#### APPEAL SUMMARY

Appeal ID: 31470	Project Address: 1631 NW Johnson St
Hearing Date: 4/12/23	Appellant Name: Erin Ziter
Case No.: B-008	Appellant Phone: 510-292-5399
Appeal Type: Building	Plans Examiner/Inspector: Steven Freeh
Project Type: commercial	Stories: 3 Occupancy: R-3 Construction Type: V-B
Building/Business Name:	Fire Sprinklers: Yes - NFPA 13R, Throughout
Appeal Involves: Alteration of an existing structure	LUR or Permit Application No.: 23-001378-CO
Plan Submitted Option: pdf [File 1]	Proposed use: Residential - Transient Living, R-3
	occupancy

# 1631 NW JOHNSON ST - TRANSIENT CONGREGATE LIVING

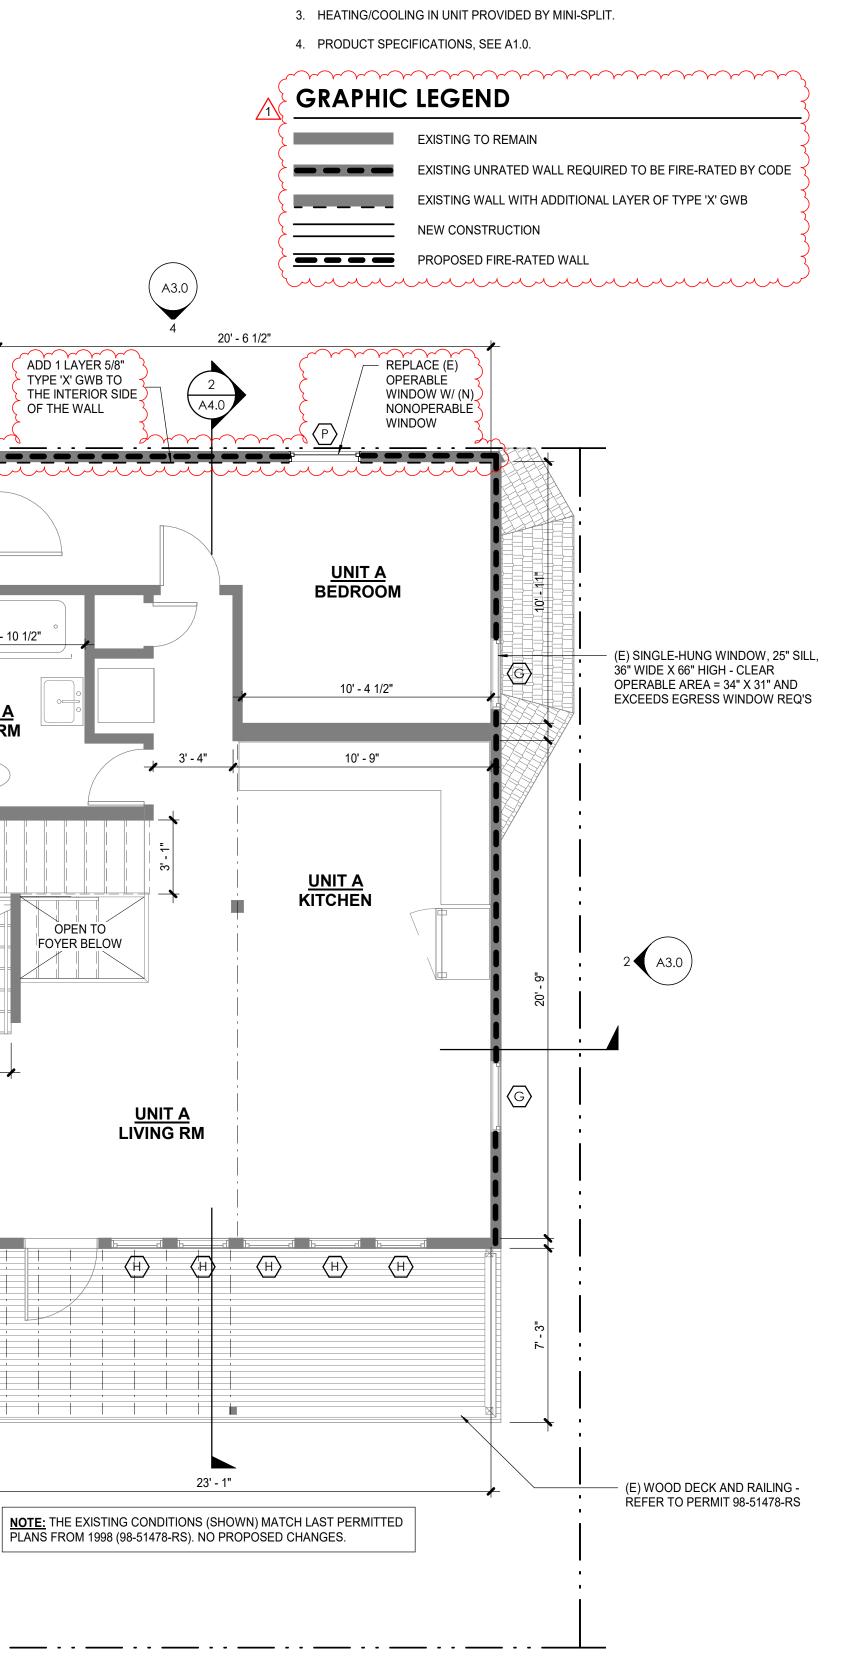
Code Modification or Alternate Requested We are requesting the west, east and north exterior walls to be non-fire rated tested assemblies.

The building is currently used as a rental property and is proposed to be used for short-term rental (transient congregate living). The proposed permit alterations are to bring the building up to code for the new short-term rental use (there are no design changes): providing the necessary fire separation between the dwelling units, and adding a NFPA 13R sprinkler system throughout the entire structure. No changes are proposed to floor plans. The existing west wall is primarily 6'-1 1/2" from the west property line. There is a 4' long bay window in the west wall that is 4'-5" from the property line. The existing north wall is approx 2" from the north property line. The existing east wall is primarily 3'-3 1/2" from the east property line. There is a 6'-11" long bay window in the east wall that is approx 1'-3" from the property line. The property to the west is a house converted to business use, the property to the north is business use, and the property to the east is a short-term rental duplex very similar to this one in permit review. The exterior of the subject property is in good condition and does not need repairs. The exterior walls are wood studs with solid T+G painted wood siding, with gypsum wall board or original lathe and plaster on the interior side. We propose no changes to the bay windows on the east and west walls. On the north wall, we propose an additional layer of 5/8" type 'x' GWB on the interior side at all feasible locations (everywhere except the kitchen wall where adding drywall is infeasible without an undue burden). If the appeal board deems necessary and acceptable, additional sprinkler heads can be placed along the north kitchen wall.

Reason for alternative Although this R-3 occupancy is governed by commercial code, this is not a commercially scaled building and should not adhere to the strict standards of the commercial code. In comparison, the residential code allows unrated walls to be 3' from the property lines. Given that the bay windows of the east and west walls make up a small percentage of the length of the structure, it would be an undue and unnecessary burden to reconstruct the exterior walls with 1 hr fire rated construction. While the north wall is significantly closer to the lot line, the added level of protection of 13R sprinklers in addition to the additional layer of 5/8" type 'x' GWB, will more than meet the current level of life safety.

- 1a. Omission of one-hour fire rating at East and West exterior walls: Granted as proposed.
- 1b. Omission of one-hour fire rating at North exterior wall: Granted provided additional sprinkler heads per NFPA 13R are installed along North wall at each floor level.

SECTION LOOKING WEST

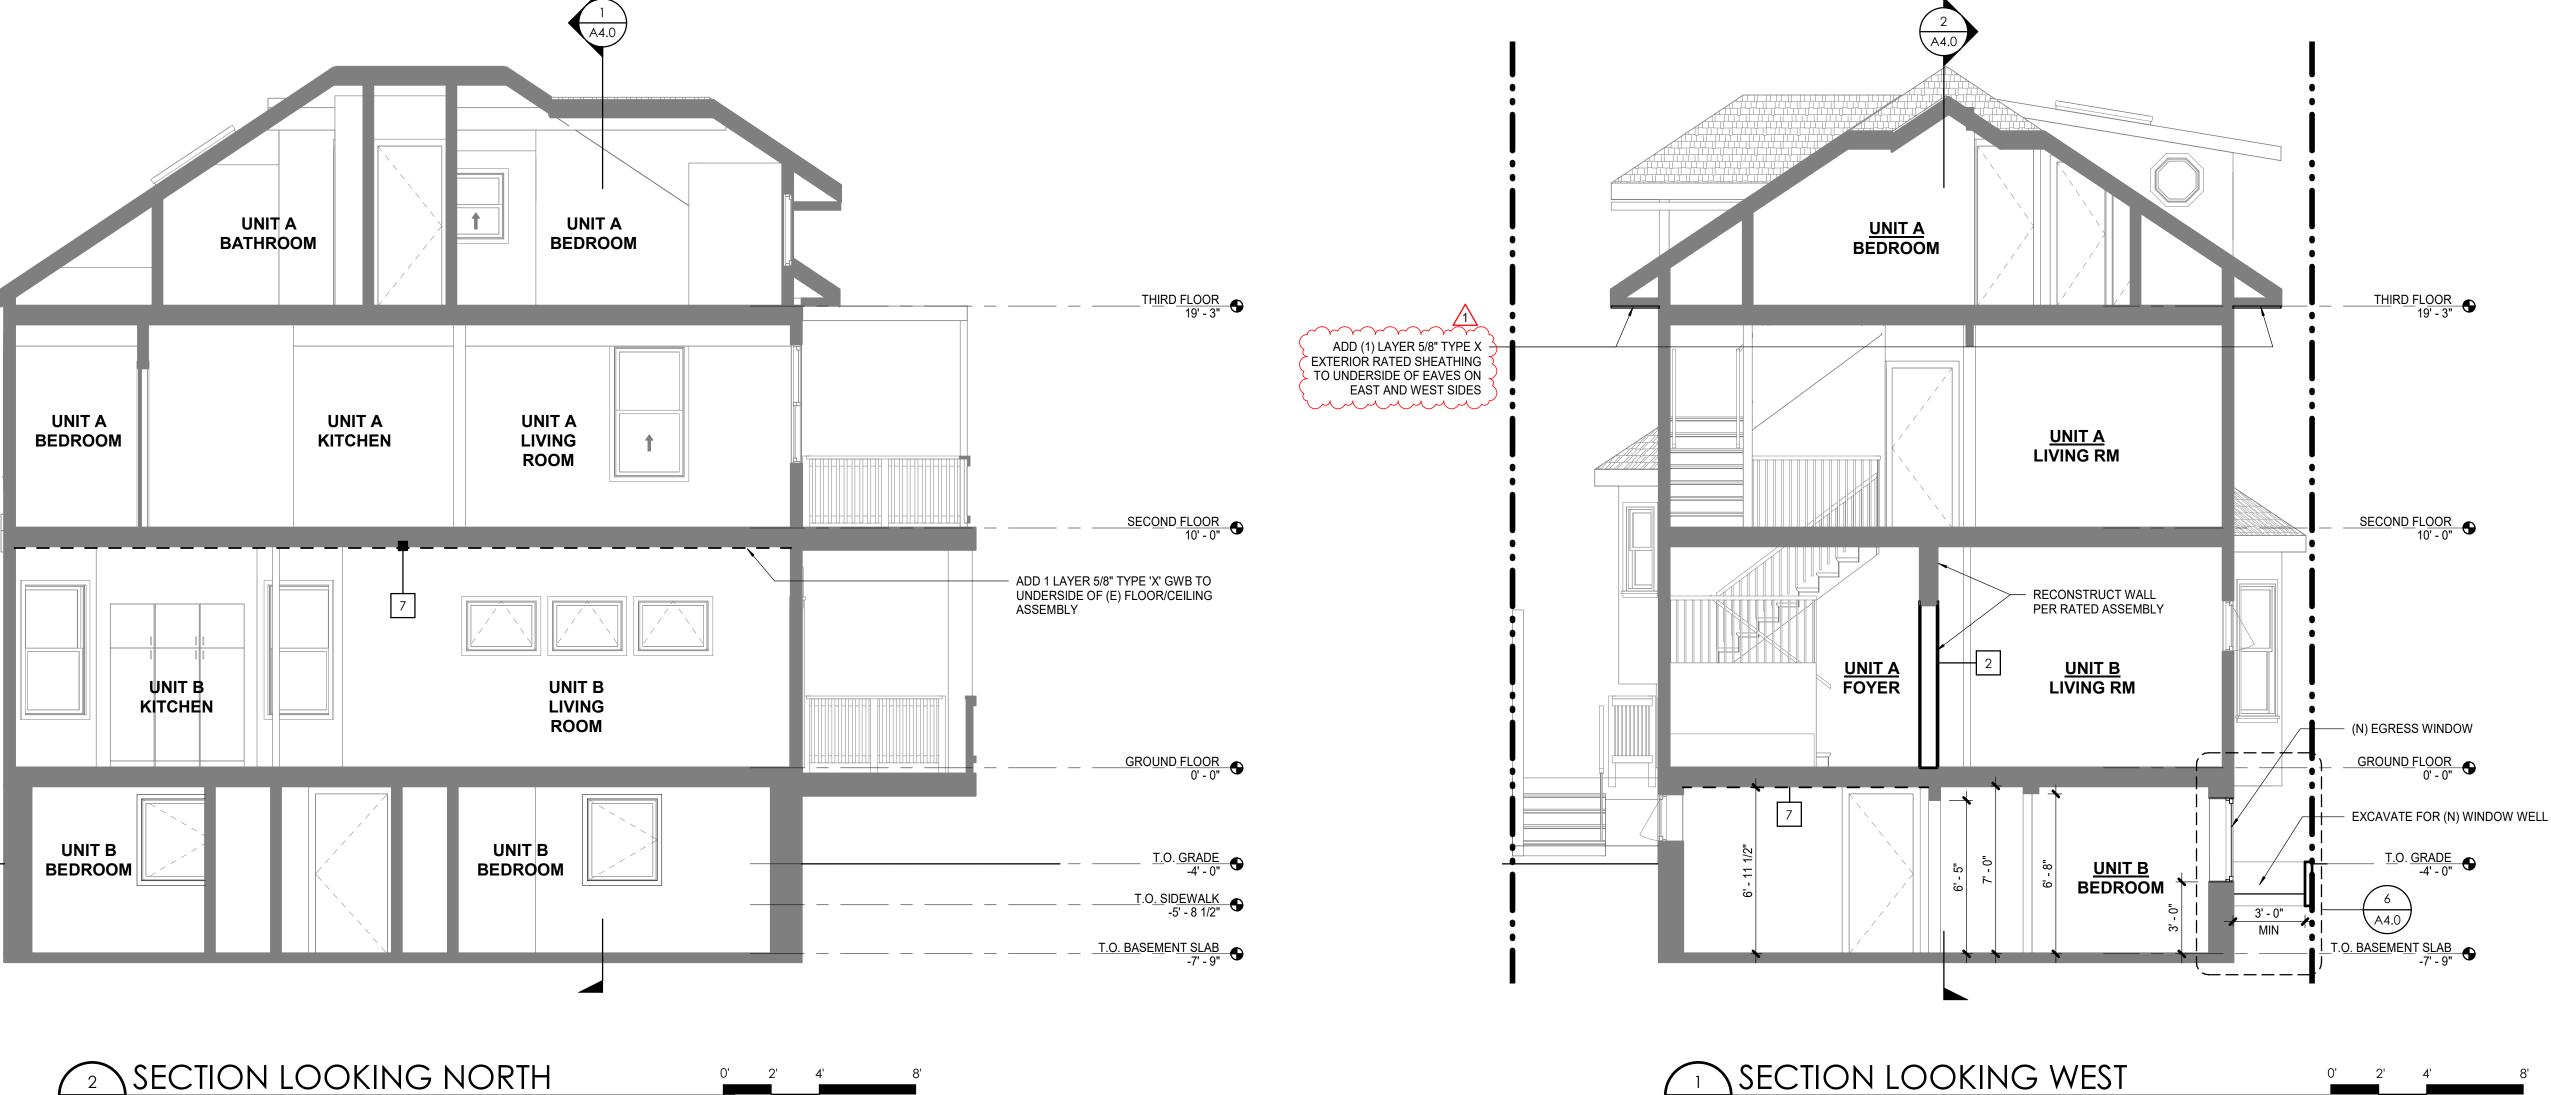
We are requesting minor modifications to the four code sections above in regards to the stair between the basement and the main level: one run that is less than 36" wide, one run with headroom less than 80", one run with 8" risers, and one landing that is less than 36" deep.

The existing stair connects the basement to the main level with a midway landing with an exterior door, thus breaking the stair into two runs. We request the top run of the existing stair remain as-is. It is 2'-9" wide, has a 2'-3 1/2" bottom landing, has 10" treads and 8" risers. We are proposing to rebuild the bottom run of the existing basement stair with a new stair in the same location. The new stair shall have a single winder tread at the top landing, then standard 10" treads, and 7 1/2" risers, and will accommodate 6'-5" of headroom. It is 3'-5 1/2" wide.

Reason for alternative The existing basement stair has a headroom low point of 5'-9". The basement stair ceiling has an assumed one layer of gypsum board directly beneath the stair framing. As part of creating a firerated separation between the two dwelling units, the basement stair ceiling needs additional layers of gypsum board to achieve a 1 hr fire-rating and STC 50 rating. We are proposing to use a 4 1/2" thick shaft wall assembly to meet these requirements. These additional layers make the headroom even lower. Therefore, we propose to rebuild the bottom run of the basement stair. By creating a winder tread at the midway landing, and rebuilding the treads as 10" deep, and risers 7 1/2" tall, we can achieve a headroom of 6'-5" the entire length of the stairway. The Portland code guide for residential basements (Brochure 9: Converting Attics, Basements, and Garages to Living Space) allows existing stairs to have 9" treads, and allows rebuilt stairs to have 9" risers. Due to the constraints of the stair location in this existing context, and the fact that this stair is within and R-3 dwelling unit, we ask you grant these alternatives.

- 3a. Reduction in the minimum required basement stair headroom from 6 feet 8 inches to 6 feet 5 inches: Granted as proposed.
- 3b. Increase in the maximum allowable riser height from seven inches to 7.5 inches: Granted as proposed.

- 3c. Location of non-compliant winder stair within top landing of reconstructed bottom run of basement stair: Denied. Proposal does not provide an equivalent level of Life Safety protection.
